Product Change Notice (PCN)

PCN Number: **PCN-0451165R-01**

Product(s) Affected: *PJ-041H*

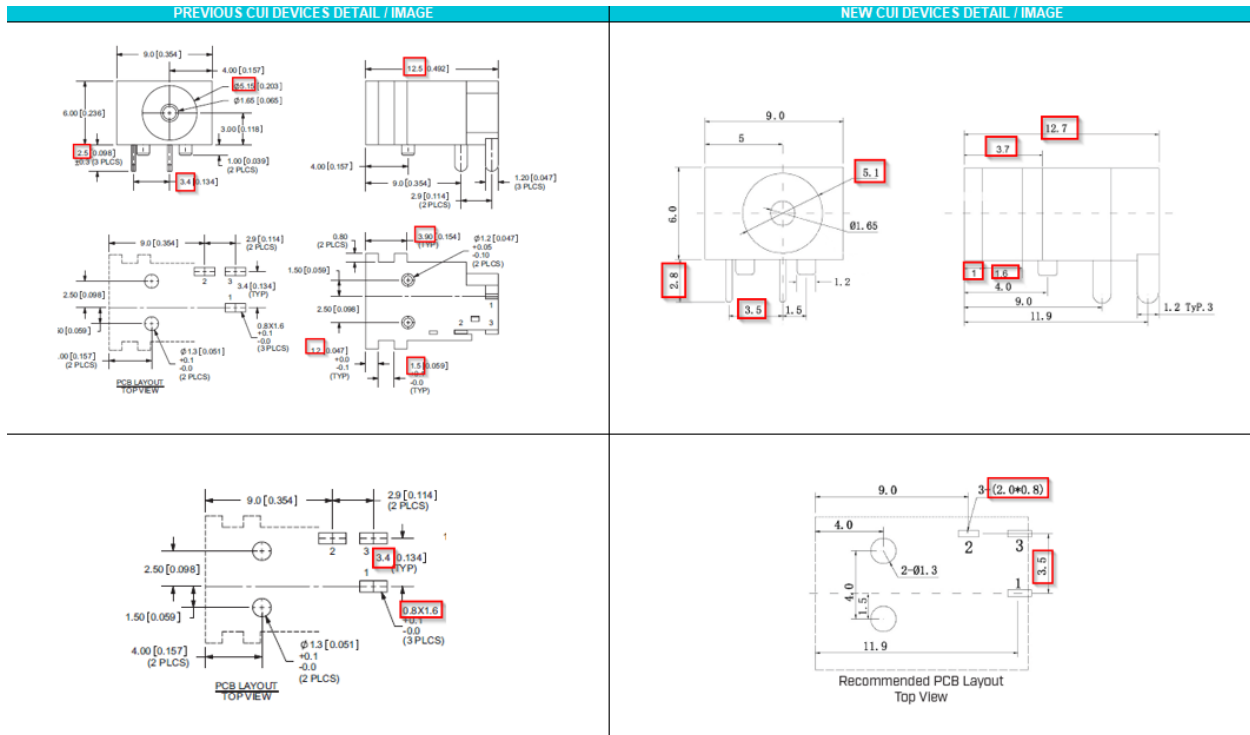
Description of Change: *Mechanical, electrical, and material changes as shown below:*

MATERIAL	PLATING
center pin	brass	silver
terminal 1	brass	silver
terminal 2	copper alloy	silver
terminal 3	brass	silver
plastic	PA66

DESCRIPTION	MATERIAL	PLATING/COLOR
center pin	brass	silver
terminal 1	brass	silver
terminal 2	C5191 phosphor bronze t=0.30	silver
terminal 3	C5210 brass t=0.30	silver
housing	PAB6 (LJL94V-0)	black
